## Service Bulletin - Recall Pending NHTSA Approval

**Recall #TS-0037:** Trailer Tire Clearance - NZ18/19/20/21, ZV20/21

**Condition:** Inadequate tire clearance

**Models Affected:** All 2021 Fiberglass Fender Nitro Z18/19/20/21 and ZV20/21 trailers with 18" wheels manufactured before 3/8/21

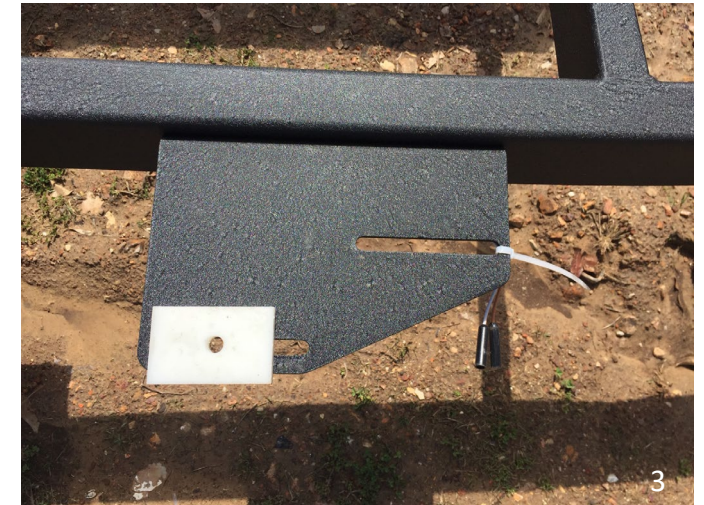
3) Remove circled bolts in image below. This will allow fender to be maneuvered to place ¼" shims.

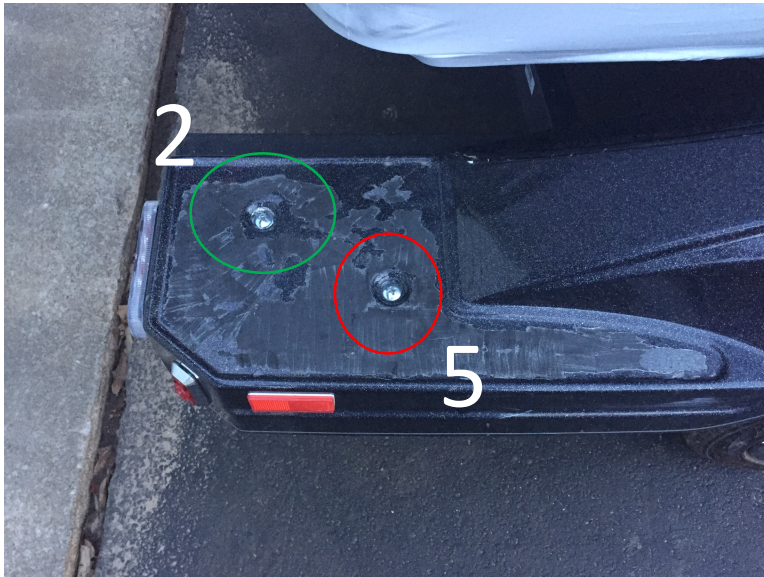
4) Place ¼" shims between mounting bracket and fender so it aligns with bolt holes. (Referenced images below shows fender removed for clarity, however, fender does not need to be removed; This should align with holes 1,2,and 3 in images above)

5) Put bolts back through the three thru-holes removed from ensuring the bolt goes through the hole in the added ¼” shims.

6) Place washers and nuts back on bolts (nuts should not be tightened down yet)

7) Push fender fully against side rail then tighten the nuts in sequence (1-5) shown in above images ensuring fender is securely fastened.

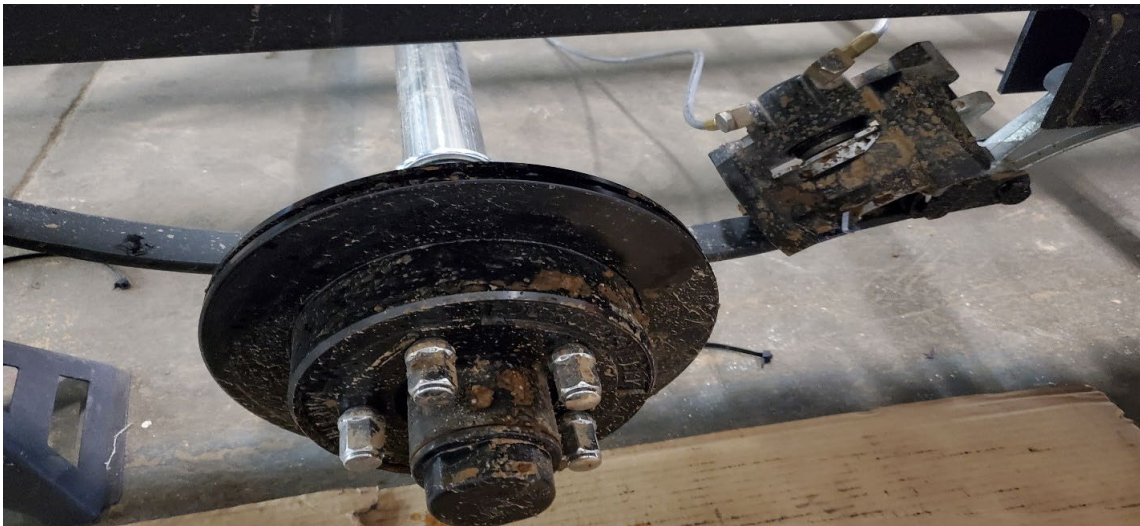
9) Bring replacement axle over to trailer. Orientation of axle must be identified to properly install new axle. There will be a dot or some type of marking on the bottom side of the axle. This mark needs to be on the curb side of the trailer (i.e. starboard side of boat).

10) Place new axle back in place. Ensure the nub of the spring seats into the hole on the spring seat. This prevents the axle from moving while in tow.
